STAFF REPORT: MARCH 8, 2023 REGULAR MEETING

APPLICATION NUMBER: 23-8232

ADDRESS: 1427 RANDOLPH

SCOPE: ALTER STOREFRONT, ADD PATIO, ADD SIGNAGE

Left: elevation of the proposed airlock. Note that the adjacent proposed patio is not depicted. Image from application materials. Right: Photo of a similar enclosure on another building. Photo provided by applicant.

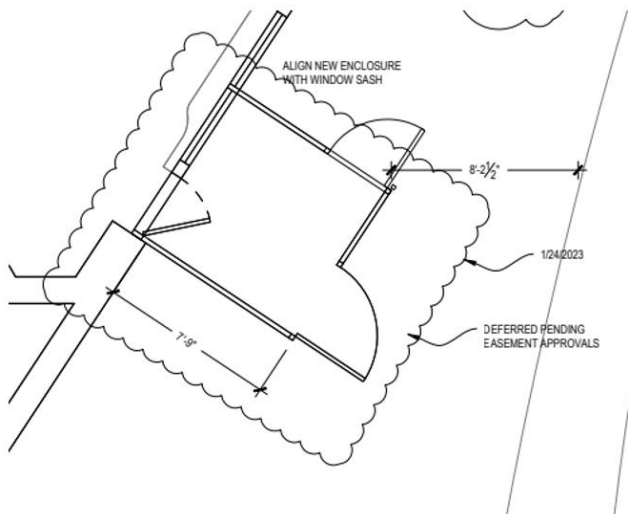
The application proposes a removeable, seasonal entrance vestibule, described as an “exterior canvas and isinglass airlock.” It would be at the south end of the façade. Fabric type and color are not specified. The projection extends 7’9” into the sidewalk, leaving 8’2½” of open pedestrian space between the projection and the curb.

- The proposed seasonal airlock vestibule obscures the front entrance, but the front entrance is not a historic, defining feature. The overall spatial characteristics of the storefront, issued a Certificate of Appropriateness in 2021, will remain intact. Due to its small scale and the fact that it is composed of temporary, soft materials, staff opines that it meets Standard #9 of the *Secretary of the Interior’s Standards for Rehabilitation*, in that it is clearly “differentiated” and “compatible with the massing, size, scale, and architectural features” of the building. It is also removeable, meeting Standard #10.

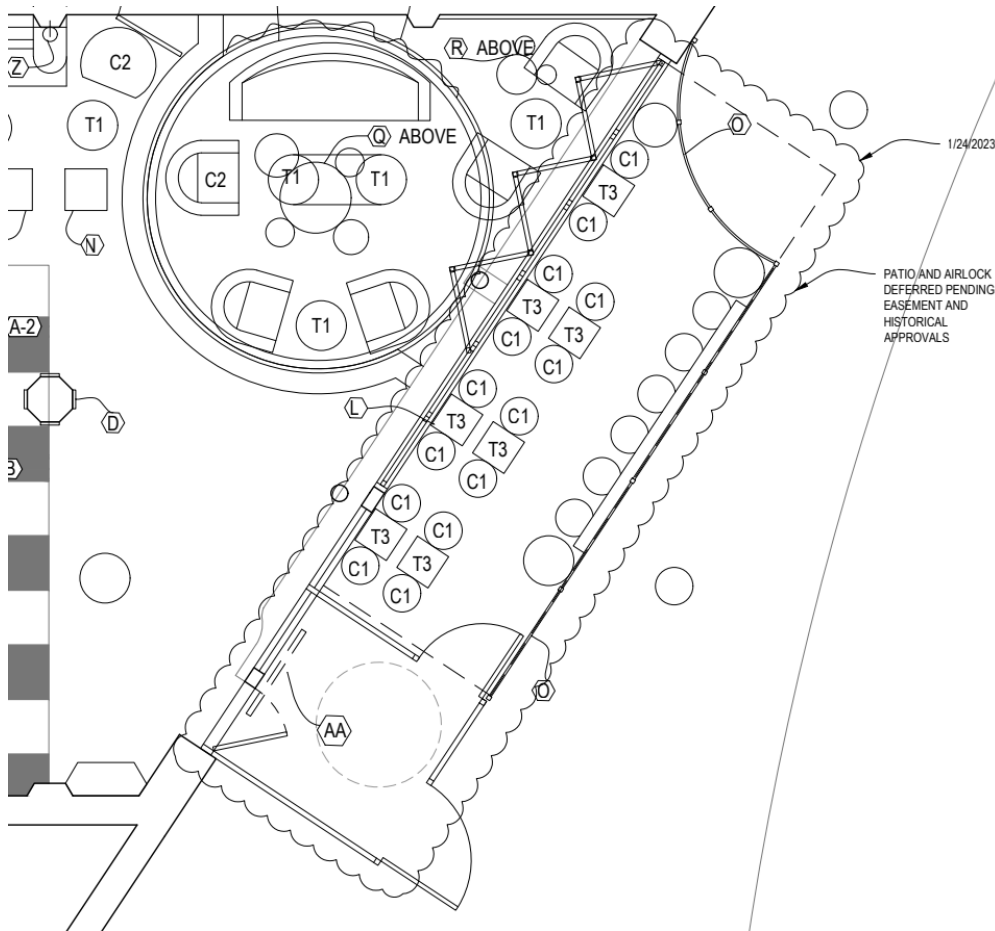
Also proposed is a “patio with metal rail and planters.” The patio projects 7’9” from the façade, leaving about 4 feet of pedestrian space between the rail and the curb at its narrowest point. The rail is to be steel with a drink ledge.

- The proposed patio is likewise differentiated, compatible, and removeable.
- The location and dimensions of the proposed awning meet the *Signs and Awning Guidelines*.

- The finish and color of the proposed steel rail is not specified.
- The appearance of the proposed planters is not shown.
- The color of the proposed awning is not specified.
- The *Signs and Awning Guidelines* provide direction on typeface, legibility, and color. Because an image for the blade sign is not provided, staff is unable to determine the appropriateness of the sign.

- The finish and color of the proposed steel rail, the selection of proposed planters, the color of the proposed awning, and the final appearance of the proposed blade sign shall be subject to approval by staff.

Left: Section from application showing dimensions. Right: Pantone 186. Image from myperfectcolor.com

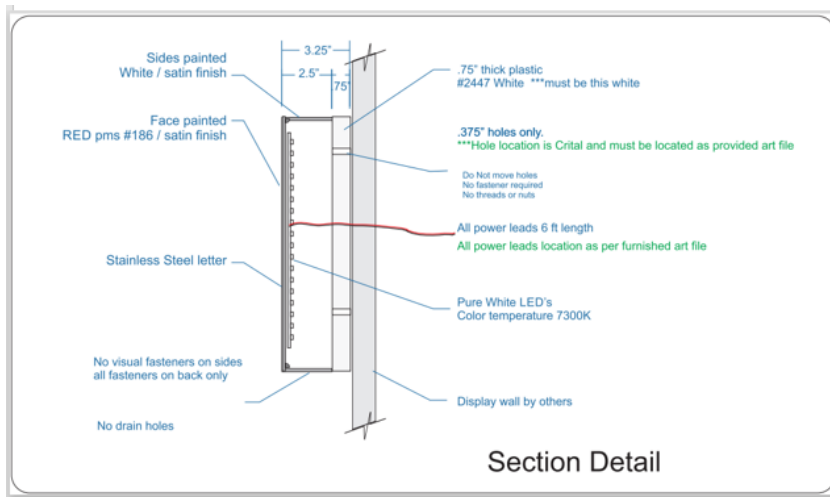
Halo-lit letters approximately 18” tall are proposed to be affixed to the building above the storefront, extending the length of the storefront windows. The letters are to be Pantone 186 Red with bright white lighting.

- The Elements of Design do not provide specific guidance for signs within the district. The proposed signs generally meet the *Signs and Awning Guidelines* and complement the character, and architectural style of the building and the district, although the information regarding the projecting blade sign is not complete (see below).

- The proposed signs are sized and placed in a matter that does not obscure, distract from, or overwhelm architectural elements of the facades. Staff therefore suggests that they are “compatible with the massing, size, [and] scale” of the façades (Standard #9) and they do not “alter features or spaces that characterize the property” (Standard #2).
